Report: TAB Report
Function: Test, Adjust, & Balance
Date: 01/18/2026
Completed By: National TAB

Fieldstone @ Chester Springs ALF (Chester Springs, PA)

Issue List

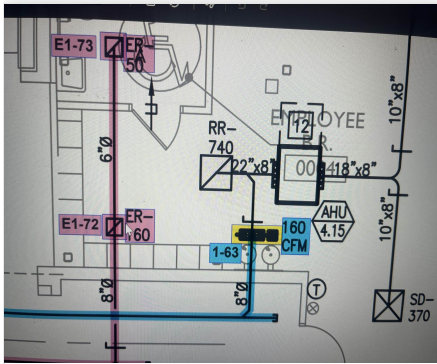
Issue Name : Basement exhaust fire damper
Description : There is a drop off in flow from the first floor exhaust duct down to the basement, branch dampers on the first floor and basement confirmed full open. The fire damper was inspected and confirmed fully open, but there is audible turbulence and the damper is internal to the duct and looks to be taking up 35-40% of the duct flow area.

- **01/28/2026 National TAB - Tyler Youells**
 - Suspect the fire damper is the cause of low exhaust flow on the first floor and recommend upsizing damper size.

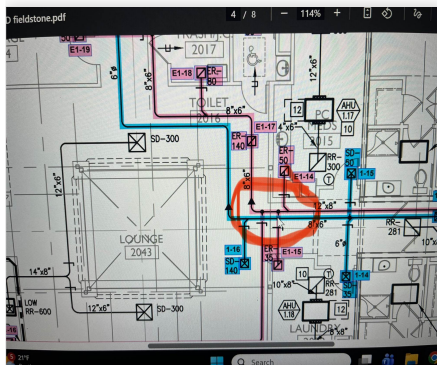
Issue Name : Locker room exhaust E1-72
Description : Exhaust register E 1-72 serving the locker room is installed as a 6" neck for 160CFM, Basement exhaust is already low but this exhaust register is at 22cfm. recommend upsizing the duct to 8" to allow for more flow.
Created By : National TAB **Assigned To :** National TAB - Tyler Youells
Status : Open
Priority : Medium **Asset Tag :**
Originated Date : 01/28/2026 - Tyler Youells - National TAB
